COMMUNITY CARE – FLATWOODS FITOUT

ADDENDUM #4

December 6, 2022

THRASHER PROJECT #060-10268

SK-P1

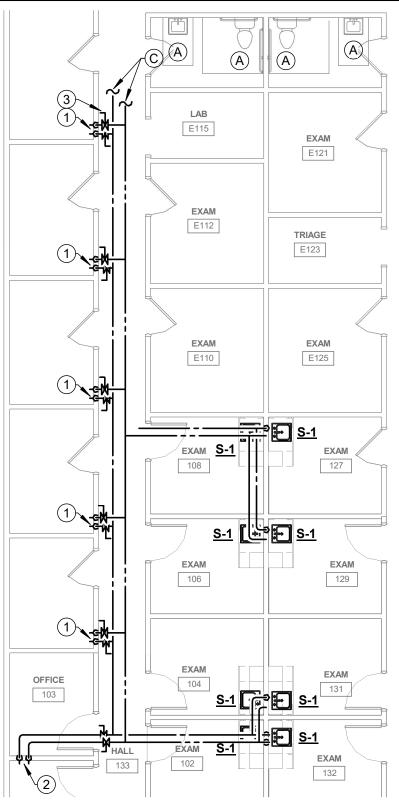
- 1/2" HOT WATER AND COLD WATER LINE. STUB AND CAP WATER LINES FOR FUTURE USE.
- 2. 3/4" HOT WATER AND COLD WATER LINE DOWN. BRANCH 1/2" TO EACH ROOM. STUB AND CAP WATER LINES FOR FUTURE USE.
- BALL VALVE. TYPICAL.

SK-P2

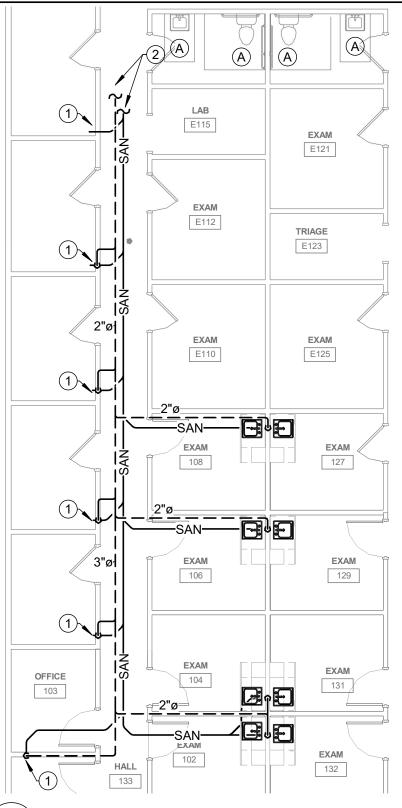
- 1. 2" SANITARY LINE CAPPED FOR FUTURE USE.
- 2. LOCATE AND CONNECT TO EXISTING SANITARY AND VENT LINE.
